## ASSESSMENT REPORT

### GOSFORD HOSPITAL SSD 6913 MOD 2

**Figure 3 – Comparison of approved (top) and proposed (bottom) eastern elevation (Showground Road)**

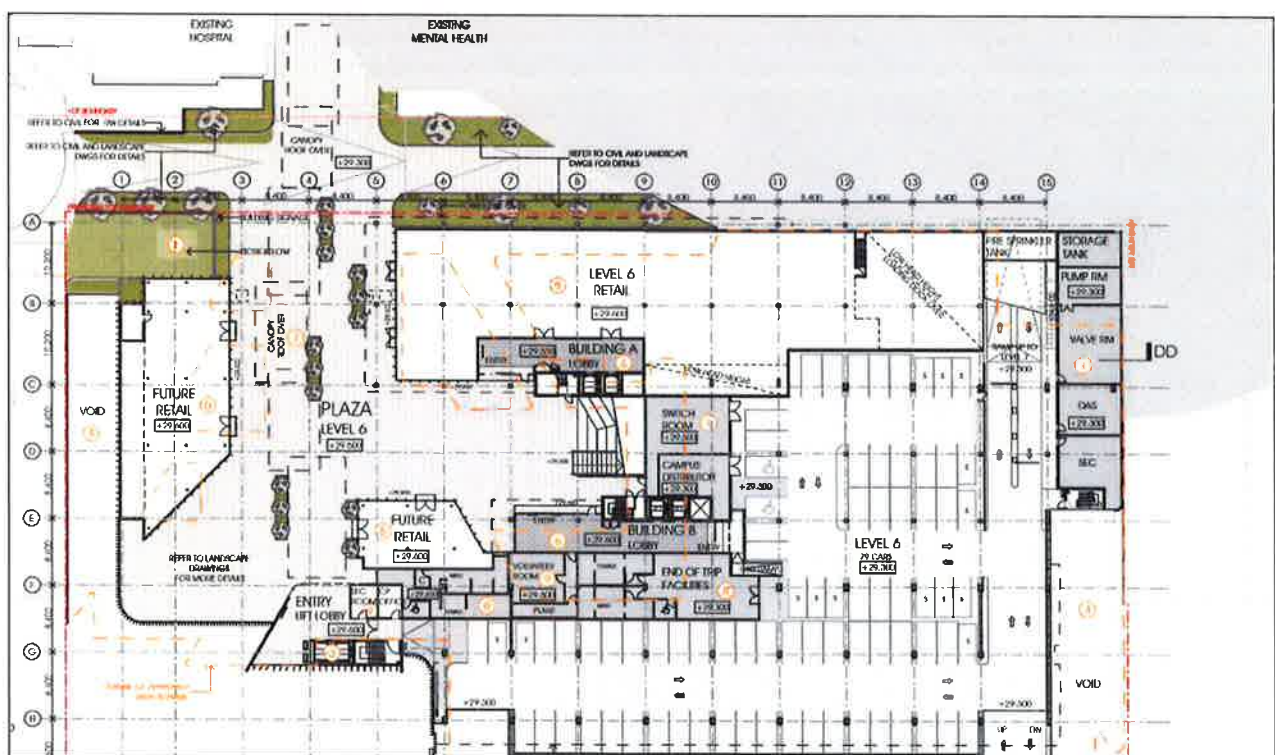
A comparison of the approved and proposed external changes to the building design; the layout of the entry hub and public plaza; and the subdivision layout are illustrated in **Figures 3 to 7**.

Figure 7: Comparison of approved (left) and proposed (right) subdivision layout

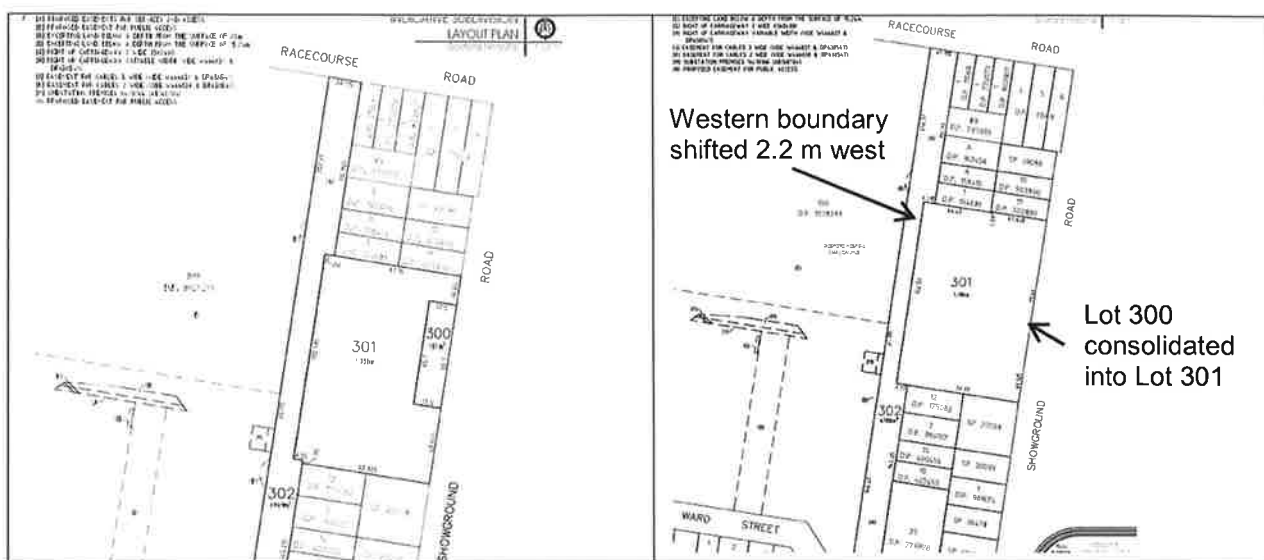
<b>Buses</b>	<ul style="list-style-type: none"> <li>TfNSW recommended consultation regarding the proposed changes along Showground Road and consideration of the impact on public bus services, bus stops and pedestrian access to bus stops on Showground Road.</li> <li>The Department notes the provision of bus services and bus stops was considered in detail in the assessment of the original application and existing Condition B20 requires the provision of bus stops in Showground Road, designed in consultation with TfNSW.</li> <li>The Department considers the proposed modifications do not affect the future provision of bus stops and existing Condition B20 satisfies the recommendations of TfNSW.</li> </ul>	No additional conditions or amendments necessary.
<b>Subdivision</b>	<ul style="list-style-type: none"> <li>The western boundary fronting Holden Street will be moved 2.2 m west and the 'future development lot' will be removed and incorporated into the HWP development. This would result in an increase in site area from 11,502 sqm to 11,808 sqm. The Department is satisfied the changes to the subdivision layout are minor and acceptable.</li> </ul>	The subdivision Conditions D7 to D9 are modified accordingly.

**Figure 8:** *East-west section through the carpark*

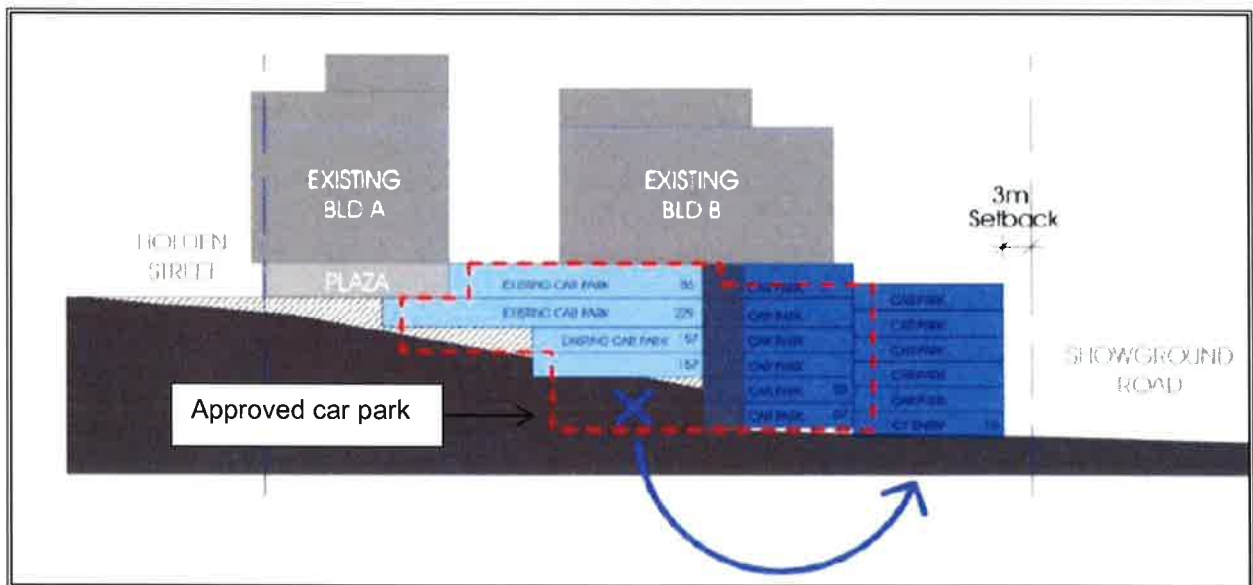
The proposal seeks approval to shift the development footprint of the carpark facility forward towards Showground Road as the future development lot currently occupying this space is no longer required. The proposal would also minimise the extent of excavation required for the development. The modified carpark facility would have a three metre setback from Showground Road with a street frontage height of 15 m. The proposal also seeks to increase the side setbacks (currently approved on the common boundary) to between six metres and nine metres. These changes are illustrated in **Figures 8 and 9**.

Council do not object to the proposed changes but recommended the inclusion of design measures such as vertical gardens to assist in reducing the visual impact of the amended carpark facility facing Showground Road.

The Department has carefully considered the potential built form and visual impacts associated with the proposed changes. Despite the increased bulk and scale of the car park facility, the Department is satisfied the proposal does not require the incorporation of vertical gardens, and is acceptable for the following reasons:

- the modified building complies with the planning controls which apply to the site. The proposed 15 m high building would sit well below the 18 m maximum height control under Gosford Local Environmental Plan 2014 (GLEP 2014) and the proposed 3 m setback to Showground Road exceeds the minimum setback control of 2 metres under the Gosford Development Control Plan 2013 (GDCP 2013);

- the proposed three metre front setback includes landscaping (tiered planter beds incorporating trees) which would appropriately soften the appearance of the carpark facility and improve the pedestrian amenity at street level;

**Figure 9:** Southern elevation administration buildings

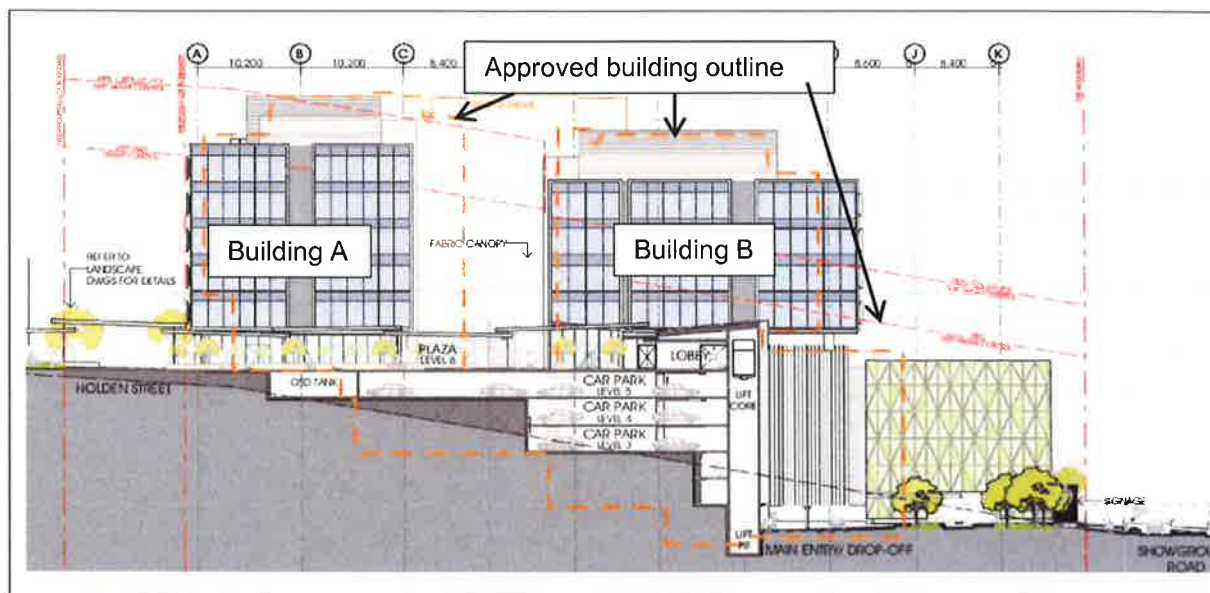
- repositioning of the westernmost tower (Building A) three metres to the west;
- expanding the footprint of the easternmost tower (Building B) five metres to the east;
- minor reduction in height of building A of Building A (-900mm) and Building B (-500mm); and
- changes to the materials, colours and finishes of the building facades.

- the majority of the additional building bulk arises from expanding the footprint of Building B towards Showground Road. The change to this part of the building would not be readily perceptible from the surrounding public domain as it will be set back 18 metres behind the building line of the proposed carpark and therefore the dominance of the building when viewed from the street is reduced by the carpark structure;

- the visual impacts of extending the building towards the street would be partially offset by the reduced height of the building, noting the wall height of the building as it presents to Showground Road would reduce by 0.8 metres;
